HISTORIC AND DESIGN REVIEW COMMISSION

March 15, 2017

HDRC CASE NO: 2017-094
ADDRESS: 121 GLORIETTA
LEGAL DESCRIPTION: NCB 576 BLK 15A LOT E 30 FT OF 10
ZONING: RM-4
CITY COUNCIL DIST.: 2
DISTRICT: Dignowity Hill Historic District
APPLICANT: Sylvia Lopez
OWNER: Jasen Lopez
TYPE OF WORK: Replacement of two front windows
REQUEST:

The applicant is requesting a Certificate of Appropriateness for approval to replace the two non-original aluminum windows beneath the front roof gable with new fixed, vinyl windows with divided lights.

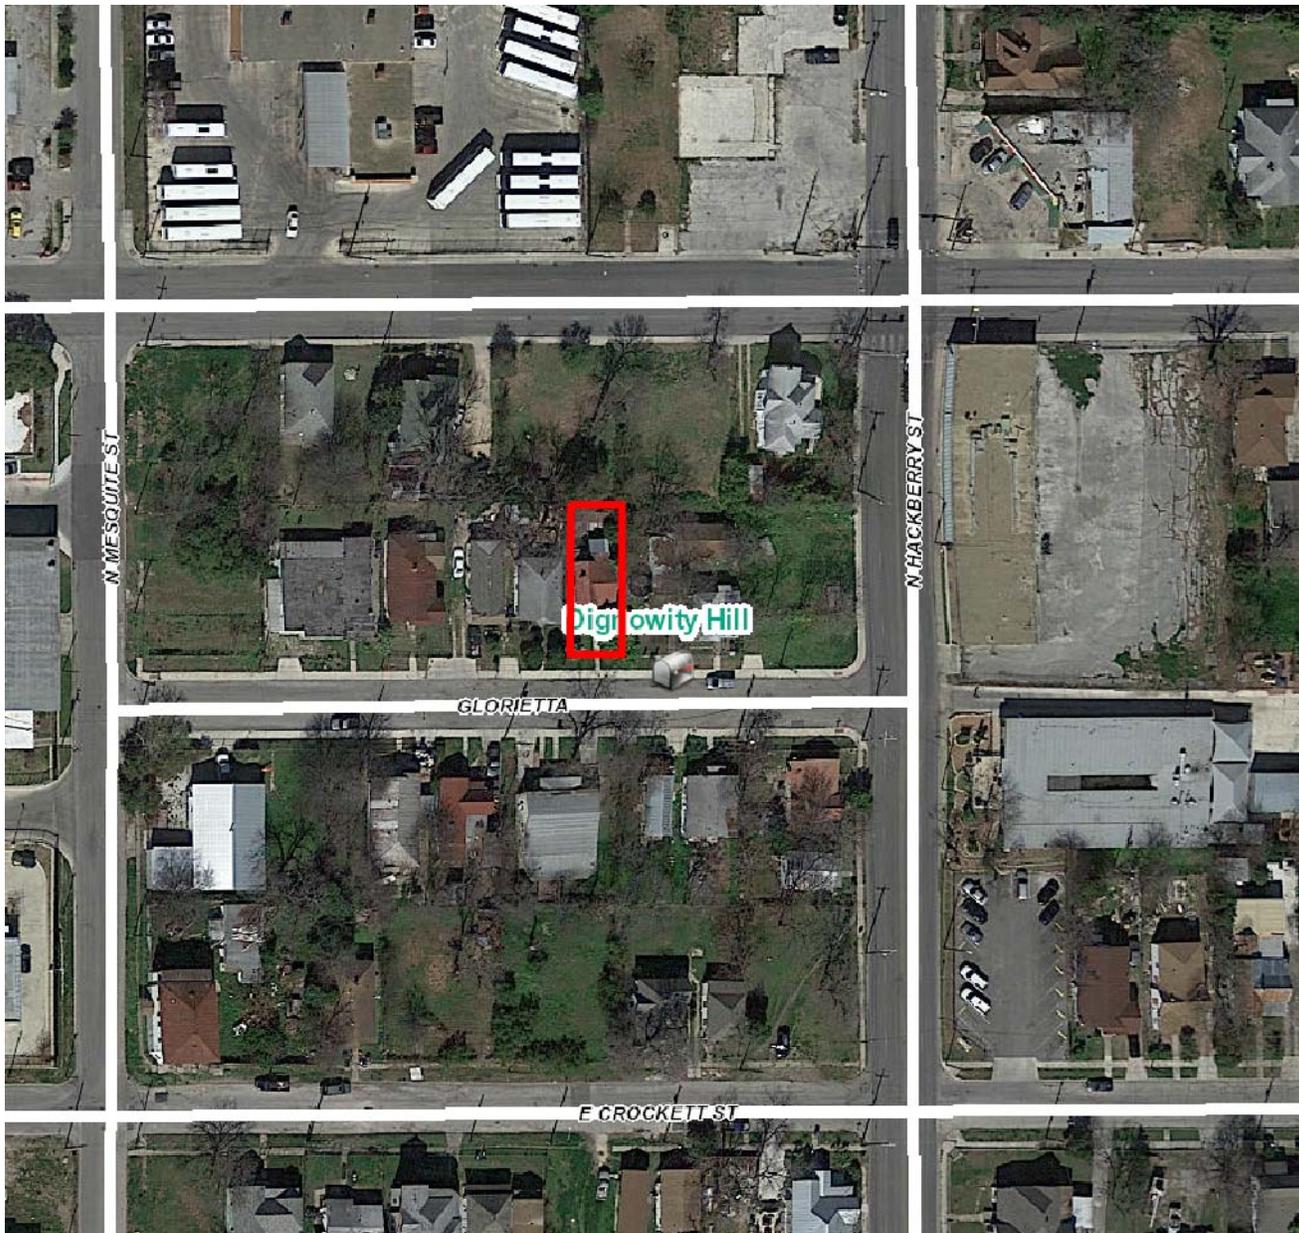
- a. The structure at 121 Glorietta was constructed circa 1910 and features traditional architectural elements including a brick chimney and a standing seam metal roof. The front façade features a recessed front porch and a front facing roof gable. Beneath the roof gable are two window openings that previously features one over one, wood windows. Currently, these openings feature aluminum windows. The applicant has proposed to remove the two aluminum windows and install two new windows that feature a profile that is not historic to this structure, four over four.
- b. Per the Guidelines for Exterior Maintenance and Alterations 6.B.vii., non-historic windows should be replaced with windows that are typical of the architectural style of the building. Staff finds that a wood window with a one over one profile is architecturally appropriate.

Staff does not recommend approval of the proposed replacement windows based on finding b. Staff recommends the applicant install wood, one over one windows, or windows with a historically appropriate profile and configuration.

EXAMPLE OF REPLACEMENT WINDOW

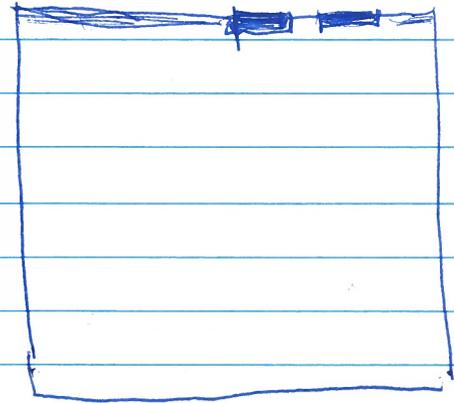
windows
to be
replaced
